Appendix A13.6 Road Safety Audit

Road Safety Audit
Stage 1
for
PROPOSED ACCESS
to
GDD WASTEWATER TREATMENT PLANT
AT
CLONSHAUGH, DUBLIN

Date: Feb 2014

Reference: RSM/MOB/281114/CLONSHAUGH-RSA1

Figure 1: Collision Plot for Road Network surrounding site (2005-2012 incl)

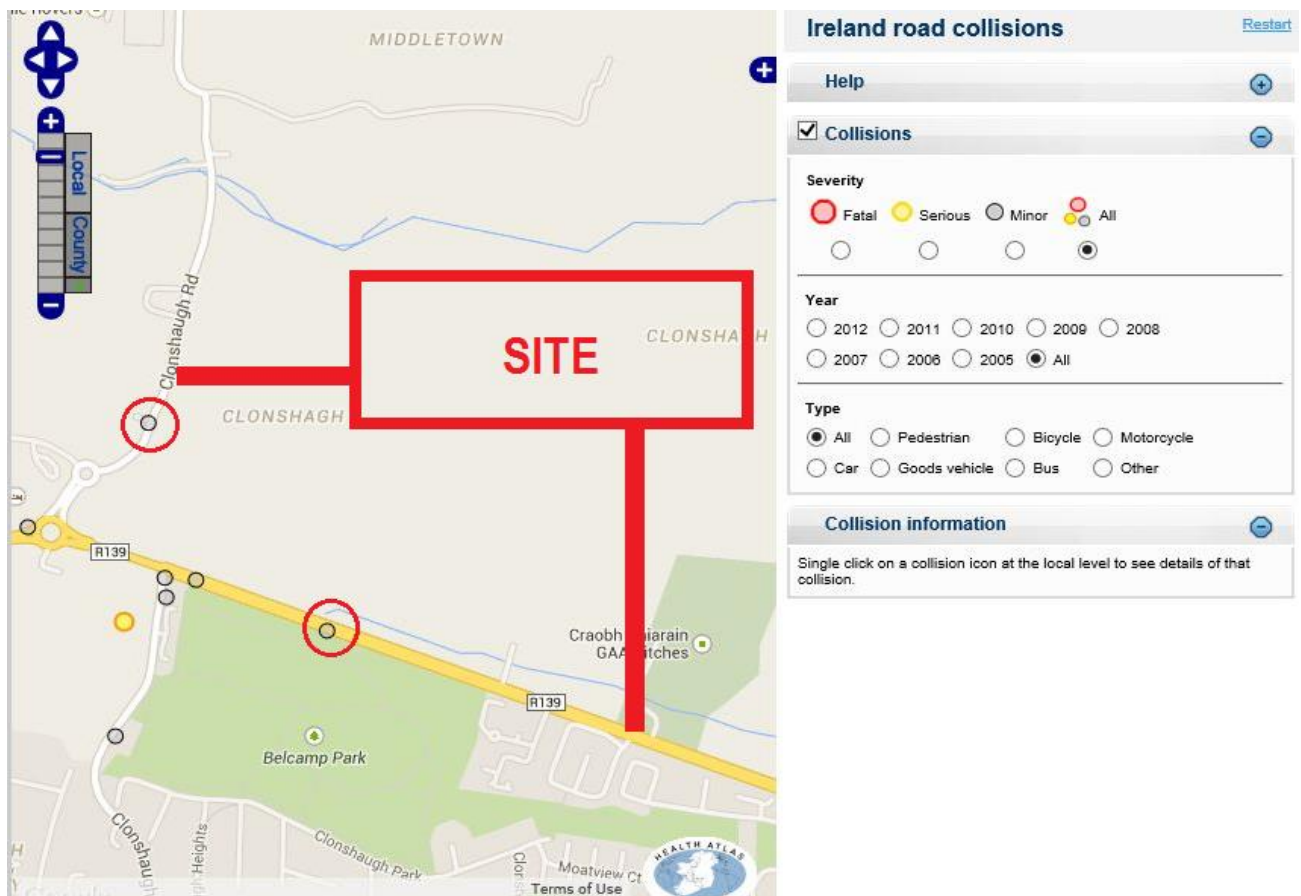
2.1.3 A preliminary review of collision data in the vicinity of the site was carried out. A review of the Road Safety Authority (RSA) online collision database indicates that there was one minor collision involving a car and a pedestrian approximately 500 west of the proposed site access on the R139, and one minor collision involving a car and a rear end shunt on the Clonshaugh Rd, approximately 100m south of the proposed site egress as highlighted in figure 1 below.

There was an additional cluster of collisions (3 minor collisions, 1 serious collision) noted in the vicinity of the junction with the R139 / Clonshaugh Rd (South), which is located approximately 900m west of the proposed site access, and an additional cluster of collisions (one of which resulted in a motorcyclist fatality) in the vicinity of the Northern Cross signal controlled junction with the Malahide Rd, which is located approximately 1km to the east of the proposed site access.

It should be noted that the RSA database is not a comprehensive record of collisions, and should be reviewed in conjunction with the Local Authority / Gardaí records for the site. Additional information was provided with reference to Fingal County Council (FCC) collision data, which indicated that there was a record of a serious collision on the R139 in 2002, and a record of two additional collisions occurring in 2002 close to the proposed access junction, both of which resulted in minor injury. The precise locations for these collisions are unknown, and have not been included in Figure 1.

VIEW TOWARDS RIGHT (NORTH) FROM PROPOSED SITE EGRESS ON CLONSHAUGH RD

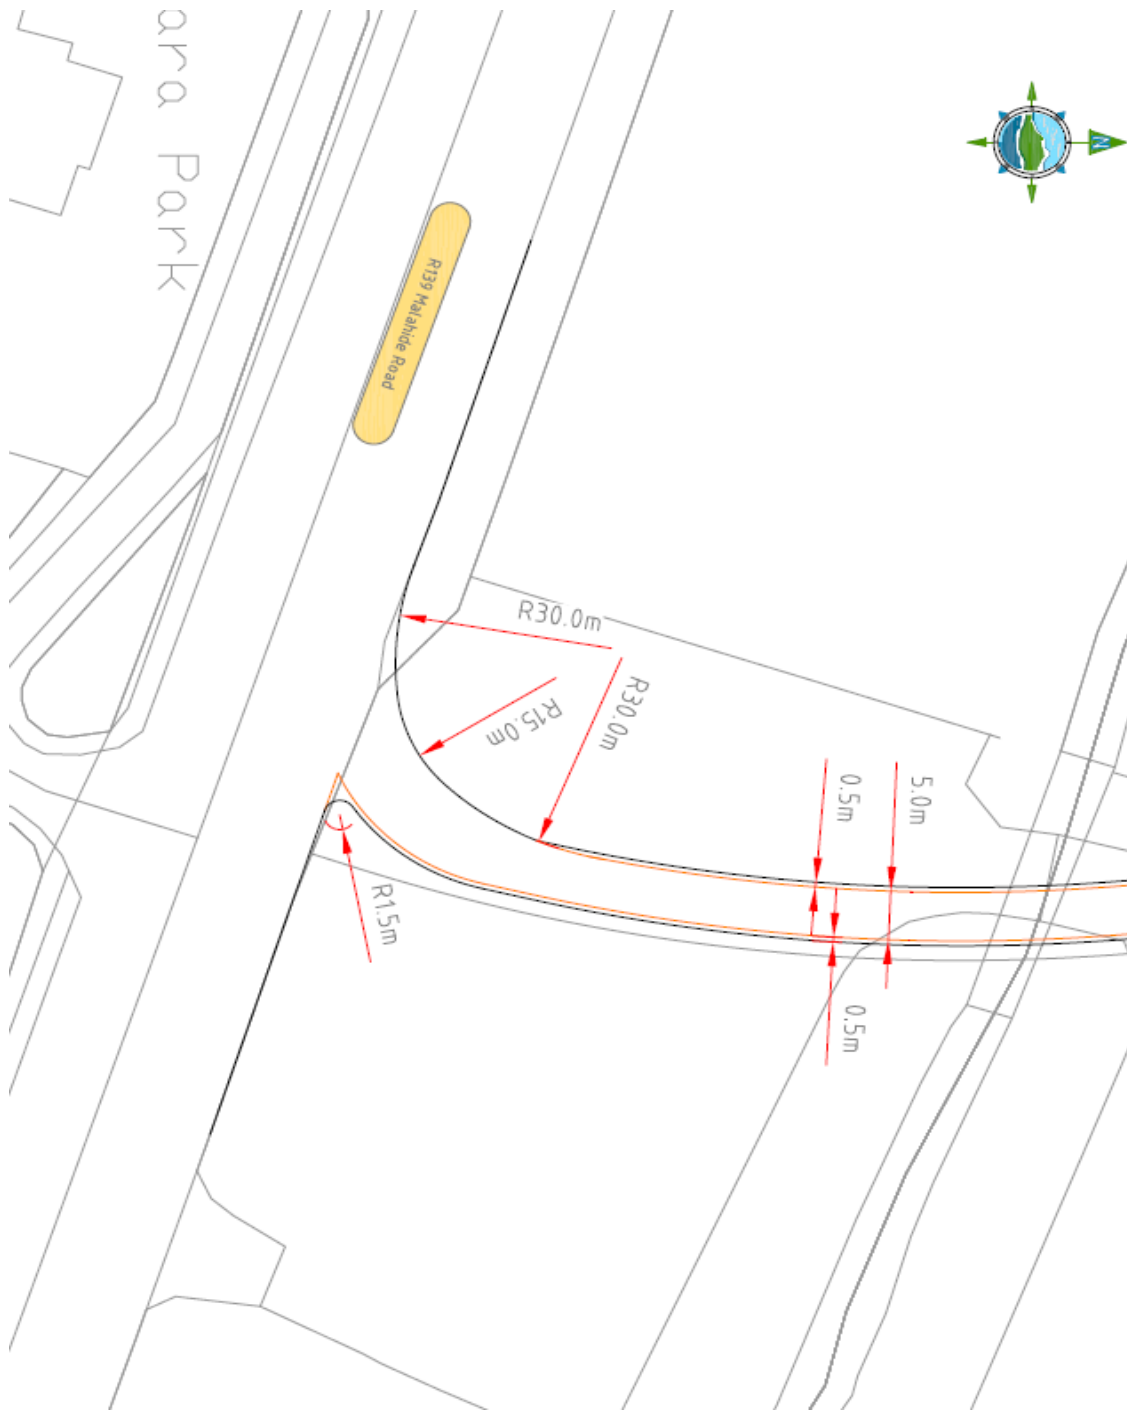
A drawing supplied to the Audit Team shows provision for land acquisition required to maintain a 3.0m x 90m visibility splay towards the right from the proposed site egress, which is welcomed since visibility towards this point is currently restricted by a back to back curve on the horizontal alignment and the boundary treatment (dense hedging) along the nearside of this approach.

3.2.2	Yes	Yes	Boundary treatments and landscaping will be developed at detailed design to ensure that the required visibility splays are maintained. It is proposed to provide gates at both the access and egress junctions in order to restrict unauthorised access to the facility. It is likely that these gates will be opened as required. The location of the gates at the access will be located to ensure that vehicles waiting to access the facility will not impact on the through movements along the R139. Details of these gates will be developed at Detailed Design stage, with proposals to be included within the scope of the Stage 2 Road Safety Audit.	Y
